UNITED STATES PATENT AND TRADEMARK OFFICE

APPLICATION NO.	FILING DATE	FIRST NAMED INVENTOR	ATTORNEY DOCKET NO.	CONFIRMATION NO.
10/720,228	11/25/2003	Dall-Hee Jung	P24462	4345
7055	7590	09/23/2005		
GREENBLUM & BERNSTEIN, P.L.C. 1950 ROLAND CLARKE PLACE RESTON, VA 20191			EXAMINER WEBB, TIFFANY LOUISE	
			ART UNIT 3616	PAPER NUMBER

Office Action Summary

DETAILED ACTION

[FIG. 2]

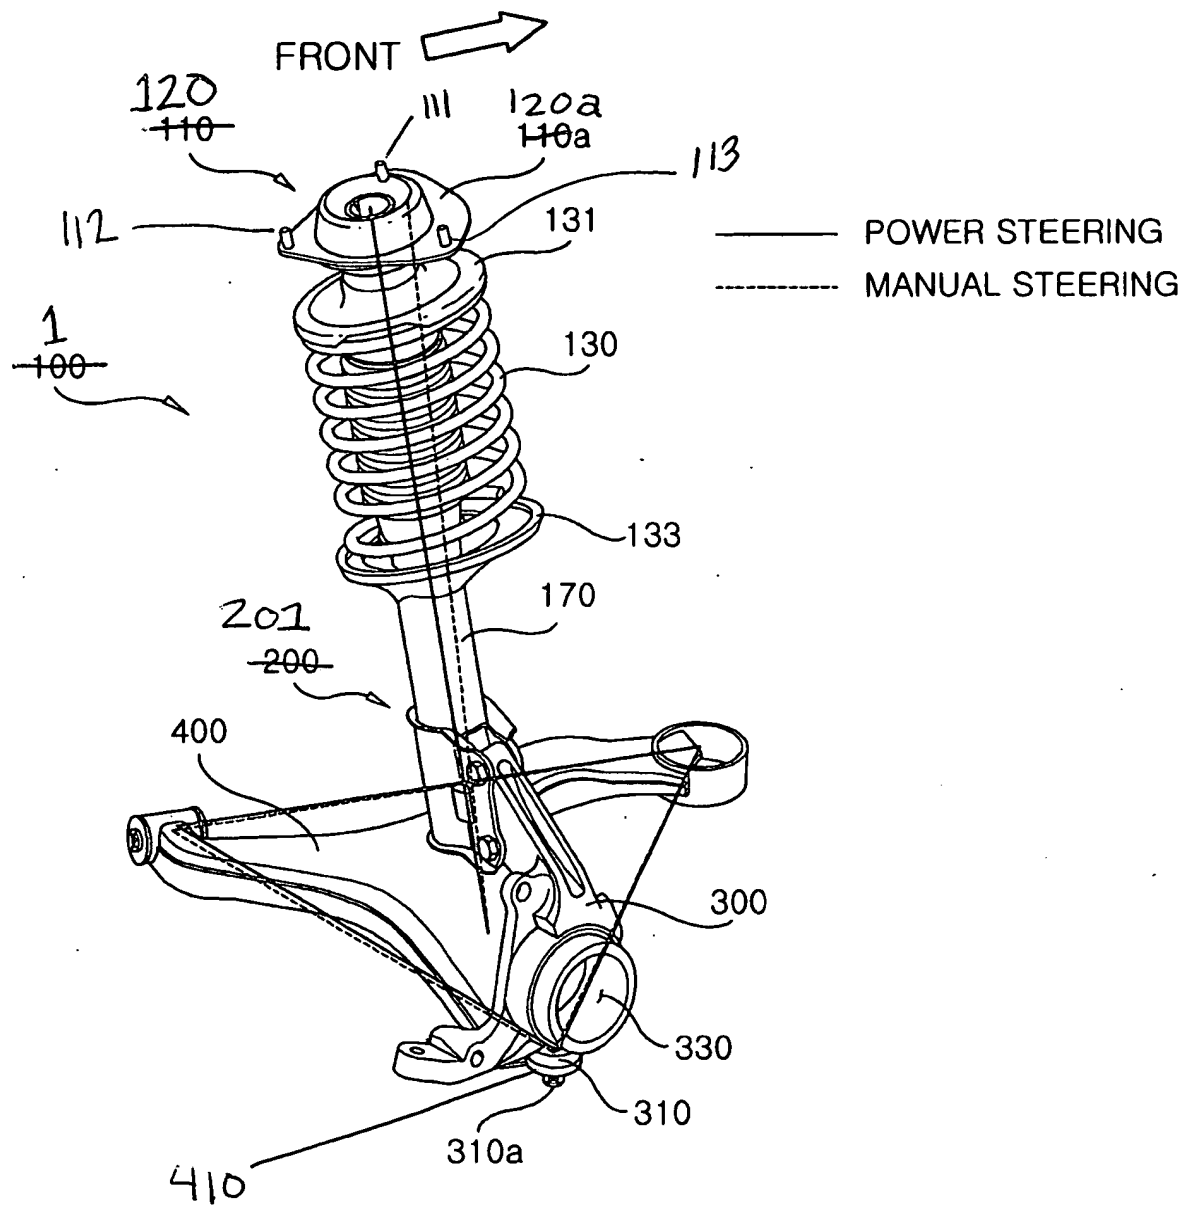
3. The drawings are objected to as failing to comply with 37 CFR 1.84(p)(5) because they do not include the following reference sign(s) mentioned in the description: 410. The detailed description states that reference character "410" is in Figures 2 and 3 (page 7, lines 7-10). Also, reference characters 111, 112, and 113 for mounting bolts are not in Figure 2, in which the detailed description describes their location (page 8, lines 1-2). A copy of marked up drawings with examiner suggestions is included. Corrected drawing sheets in compliance with 37 CFR 1.121(d) are required in reply to the Office action to avoid abandonment of the application. Any amended replacement drawing sheet should include all of the figures appearing on the immediate prior version of the sheet, even if only one figure is being amended. Each drawing sheet submitted after the filing date of an application must be labeled in the top margin as either "Replacement Sheet" or "New Sheet" pursuant to 37 CFR 1.121(d). If the changes are not accepted by the examiner, the applicant will be notified and informed of any required corrective action in the next Office action. The objection to the drawings will not be held in abeyance.
